Commonwealth Edison Company
Zion Generating Station
101 Shiloh Boulevard
Zion, IL 60099-2797
Tel 847-746-2084

Subject: Zion Station Units 1 and 2
Response to Request for Additional Information
Operating Licenses DPR-39 and DPR-48
NRC Docket Nos. 50-295 and 50-304

RESPONSE TO NRC REQUEST FOR ADDITIONAL INFORMATION

HSST Plate 02 Surveillance Data

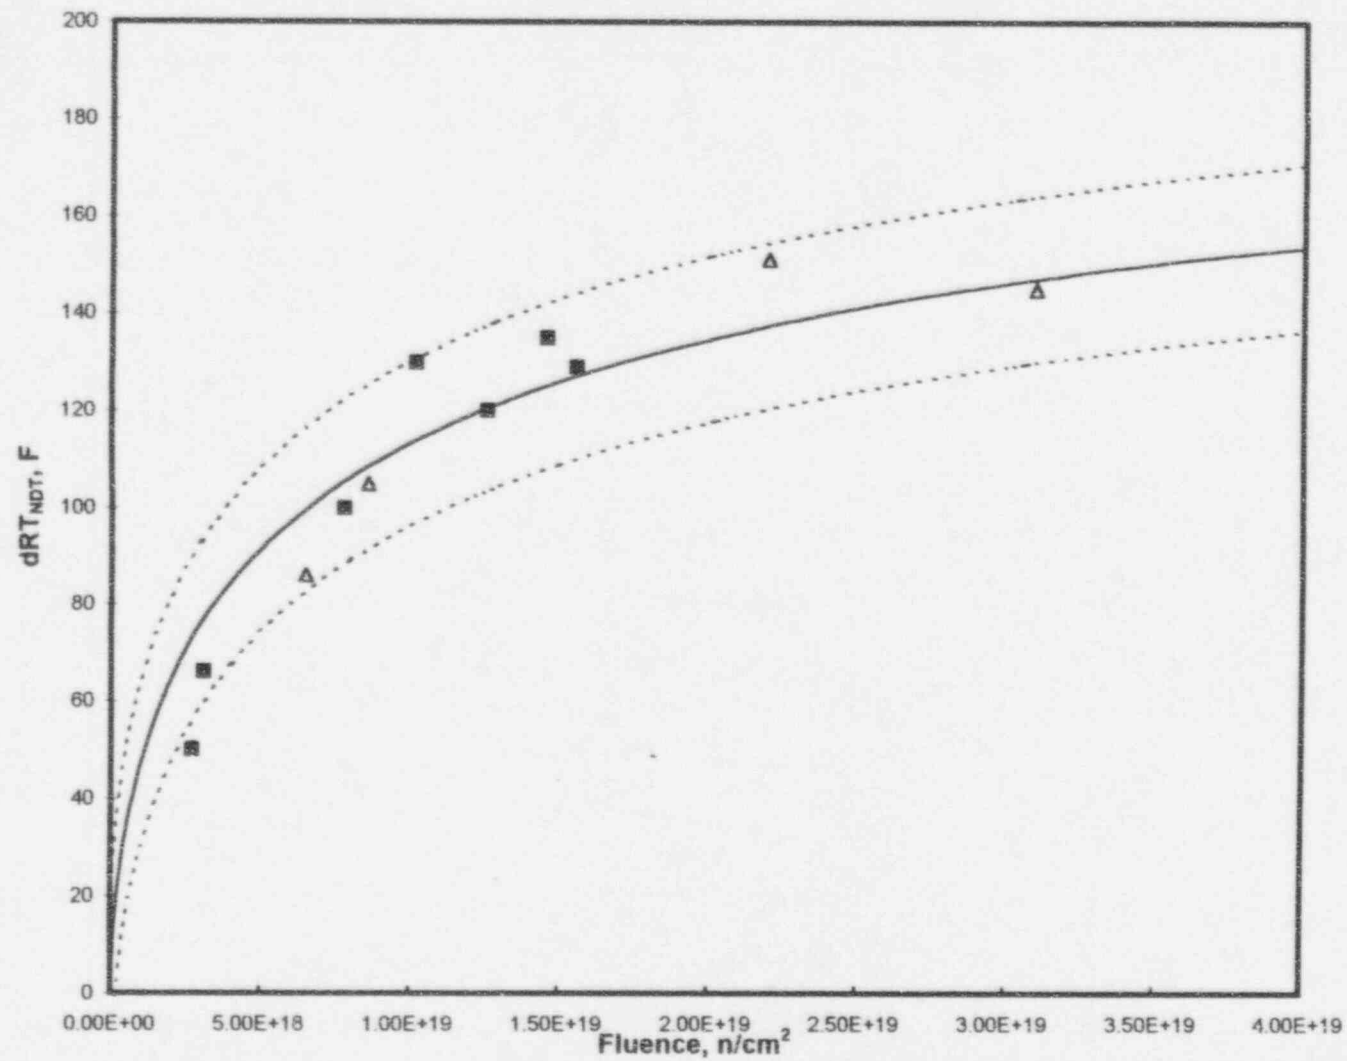
A plant-specific indication of the effect of differences between the Zion Units and Point Beach Unit 2 irradiation temperature is the behavior of identical material irradiated in all three reactors. All seven surveillance capsules from Zion Units 1 and 2 and the four Point Beach Unit 2 capsules contain identical correlation monitor material from Heavy Section Steel Technology (HSST) plate 02. When the irradiation shift of this data is plotted relative to fluence as shown on the attached HSST Plate 02 curves (with surveillance data sheet) (source - Ref. 13), there is no evidence of a temperature effect in the behavior of the material.

ComEd concludes that the 13°F irradiation temperature difference between the Zion Units and Point Beach Unit 2 is insignificant, based on actual plant-specific power reactor data on identical material. Therefore, the application of additional margin is unwarranted. Additionally, neither 10 CFR 50.61 nor Reg. Guide 1.99, Rev. 2 require such an adjustment if the irradiation temperature of the Charpy specimens is within $\pm 25^{\circ}\text{F}$ of the vessel wall temperature at the cladding/base metal interface.
